**RE: COMMENTS CONCERNING THE PROPOSED NEAR SURFACE
DISPOSAL FACILITY PROJECT AT THE CHALK RIVER LABORATORIES**

CEAA Reference number 80122

PROPOSED NUCLEAR DISPOSAL FACILITY AT CHALK RIVER, ON

Comments on the draft Environmental Impact Statement
CEAA #80122

Figure 1 - Chalk River Surface Water Monitoring Stations

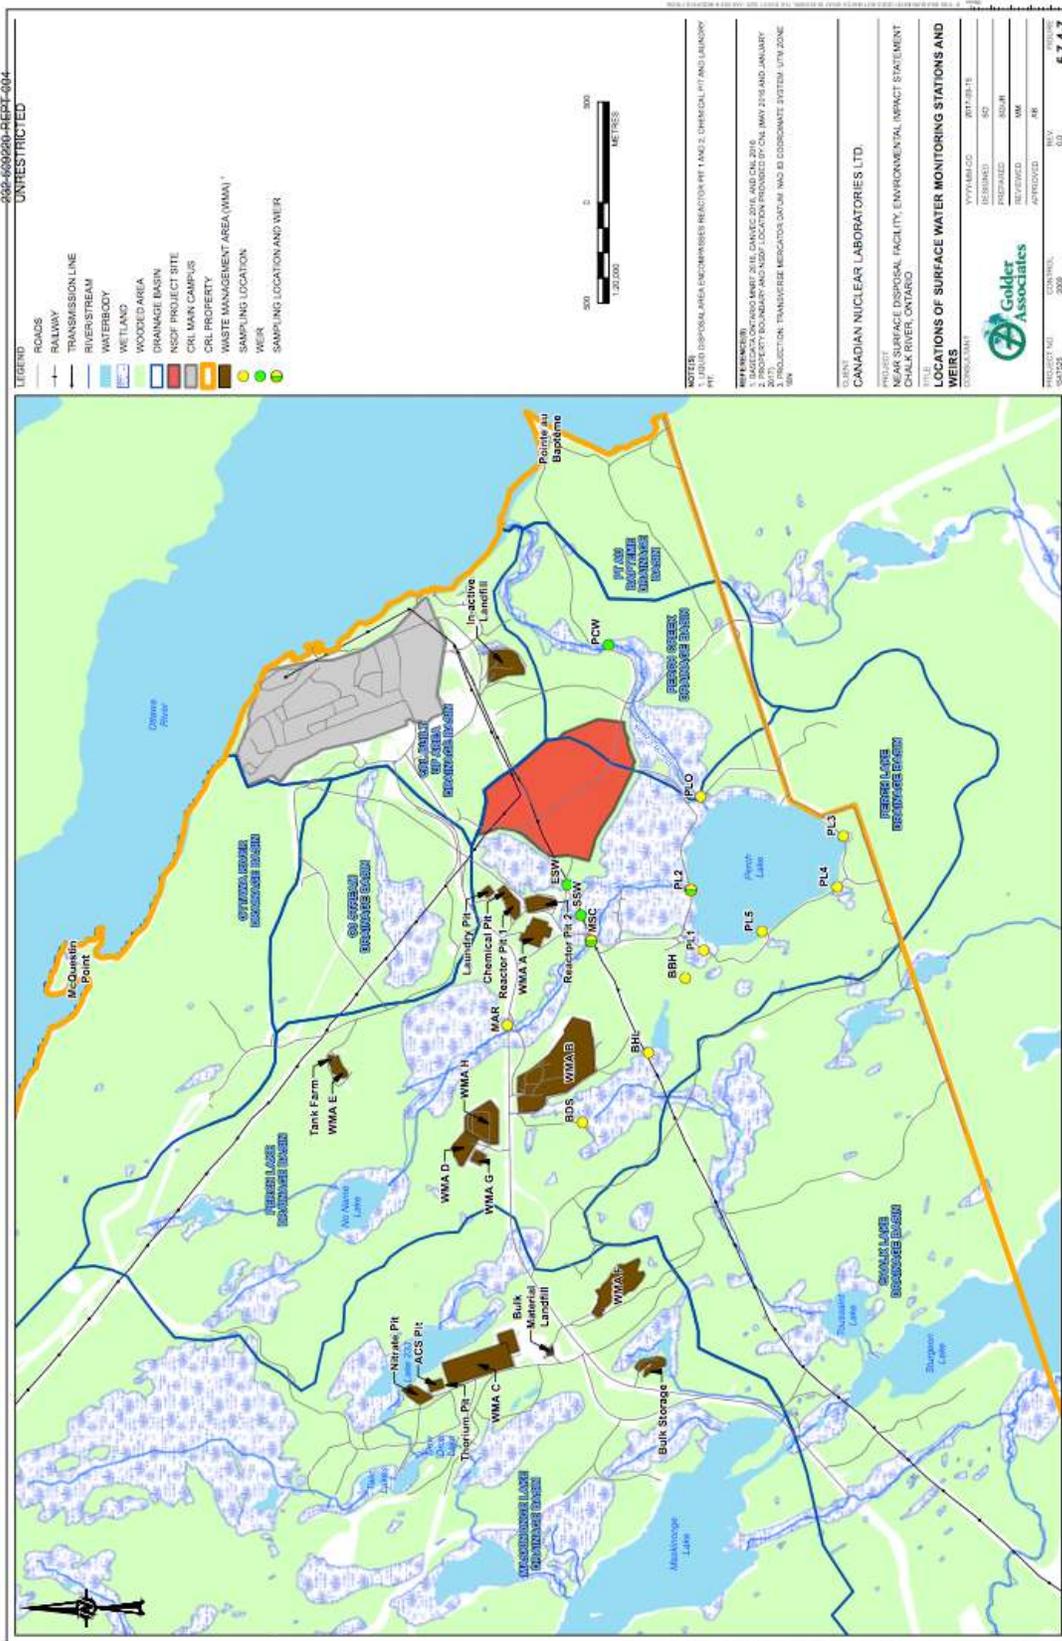
<u>Monitoring Locations</u> (see Fig. 1 on next page)	<u>Tritium Levels</u>	<u>Reference</u>
Current Tritium Levels on Undeveloped NSDF site	<64 to 155 Bq/L	p. 5-481
Tritium Levels in Groundwater in East Swamp	no disclosure provided in draft EIS	
East Swamp Weir (ESW)	359 Bq/L	Table 5.7.4-8
Perch Lake Inlet (PL2)	2,438 Bq/L	Table 5.7.4-8
Perch Lake Outlet (PLO)	3,879 Bq/L	Table 5.7.4-8
Perch Creek - Weir (PCW)	3,374 Bq/L	Table 5.7.4-8

High tritium levels are already present in Perch Lake and Perch Creek, as shown in Table 5.7.4-8, which shows average tritium levels in these surface waters of several thousand Bq/L. This means that there is only a limited capacity for addition tritium loading if the draft EIS commitment to an upper limit in Perch Creek of 7,000 Bq/L (which is based on the PWQO for tritium) is to be respected.

Instead of just providing average levels, seasonal high and low tritium levels should have been presented in the draft EIS. My sense is that there will be times (perhaps during drier summer base flow periods) when the creek is already at or near the 7,000 Bq/L limit for tritium, implying that the addition of tritium-laced WWTP effluent will push the creek over the limit.
